Technical Service Bulletin

SUBJECT:			No: TSB-19-54-001
QUICK CHARGING WITH ABB QUICK CHARGER STOPS DUE TO ISOLATION ERROR			DATE: February 2019
			MODEL: 2018-2019 Outlander PHEV
CIRCULATE TO:	<input type="checkbox"/> GENERAL MANAGER	<input checked="" type="checkbox"/> PARTS MANAGER	<input checked="" type="checkbox"/> TECHNICIAN
<input checked="" type="checkbox"/> SERVICE ADVISOR	<input checked="" type="checkbox"/> SERVICE MANAGER	<input checked="" type="checkbox"/> WARRANTY PROCESSOR	<input type="checkbox"/> SALES MANAGER

SUB-BMU REPROGRAMMING CHART

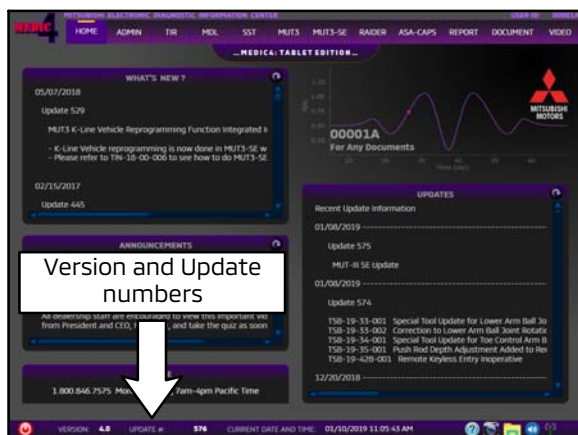
This TSB instructs dealers to reprogram the sub-BMU with updated software to correct the issue.

1. Confirm your MUT-III is updated with the latest reprogramming database.
2. Reprogram the sub-BMU with the new software. Refer to the "Sub-BMU Reprogramming Chart" for new software information.

Sub-BMU Part Number		Data Number	Software Version	
			Previous	New
9479A058	With Battery Heater	9479A201	BE3014 BE3015 BE3016	BE3017
9479A170			BE3204	BE3205
9479A057	Without Battery Heater	9479A200	BE3100 BE3101 BE3102	BE3103
9479A172			BE3403	BE3404
